Staff Report

To: Salt Lake City Historic Landmark Commission
From: Carl Leith, Senior Planner
801 535 7758 or carl.leith@slcgov.com
Date: January 3, 2019
Re: **PLNHLC2017-00696 Twin Home Development at approximately 578 and 610 N. West Capitol Street**
PLNHLC2018-00930 Special Exceptions in SR-1A Zone District

REQUEST: Twin Home Development at approximately 578 and 610 N. West Capitol Street –
Dustin Holt, DB Urban Communities, is requesting approval from the City for the construction of 12 twin homes, and associated Special Exception approvals, on a steeply sloping site which fronts Darwin Street to the east and West Capitol Street to the west. The development site consists of two distinct parcels. The development will require a subdivision of this site which will be the subject of a separate application. The site falls within the Capitol Hill District and is zoned SR-1A (Special Development Pattern Residential).

LOT 1 & 2 SITE PLAN		
Project number	Project Number	4
Date	10-14-18	
Drawn by	Author	
Checked by	Checker	
		Scale 1/8" = 1'-0"

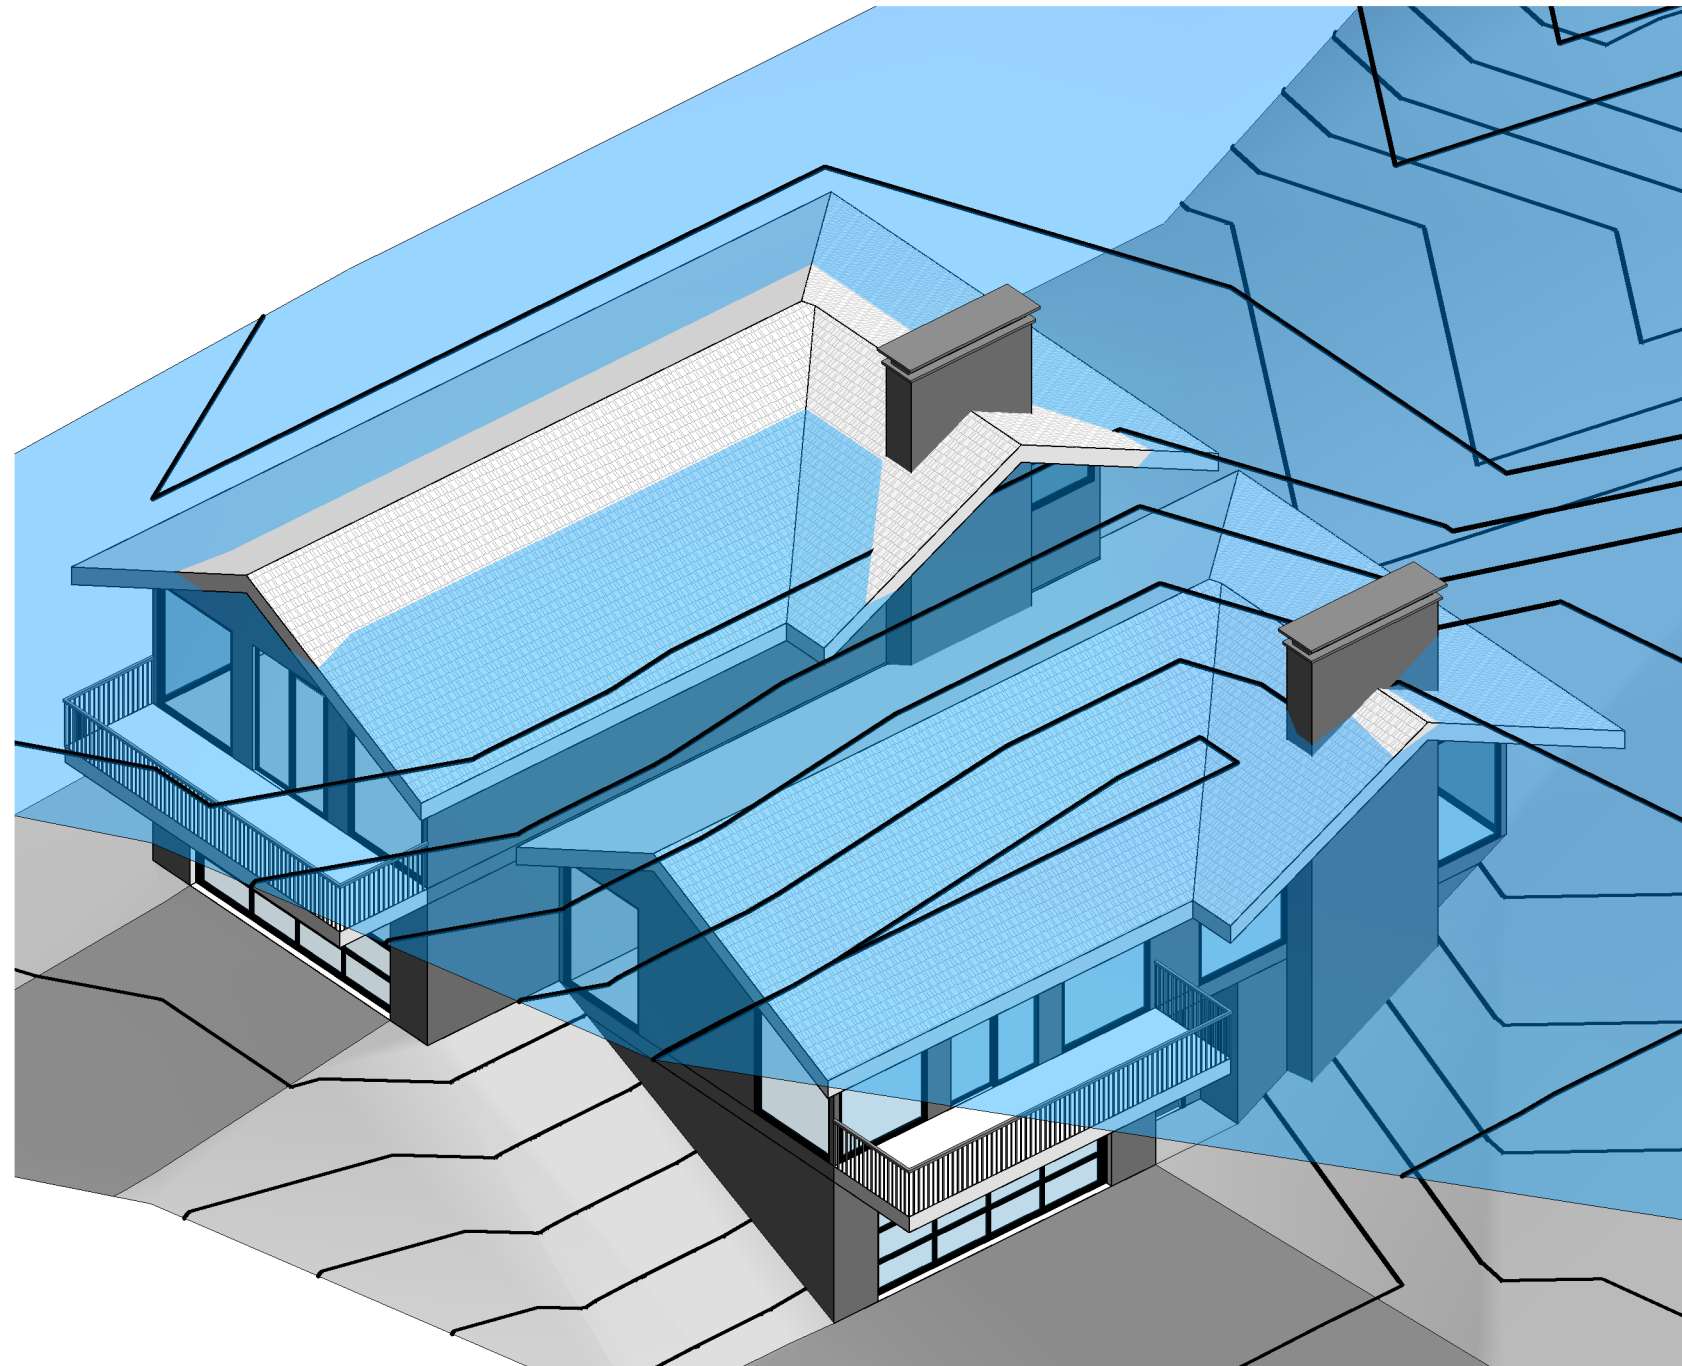
As you know a number of the neighbors meet with the developers in November and we agreed conceptually to a number of the changes (such as eliminating the private drive); however, I raised concerns about Lots #1 and #2 . While the developers have minimally changed the design to address the concerns (window panes and modest change to the entrance), their changes fall short of those identified as concerns by the Commission in their January 18th meeting and that are reflected in other guidelines.
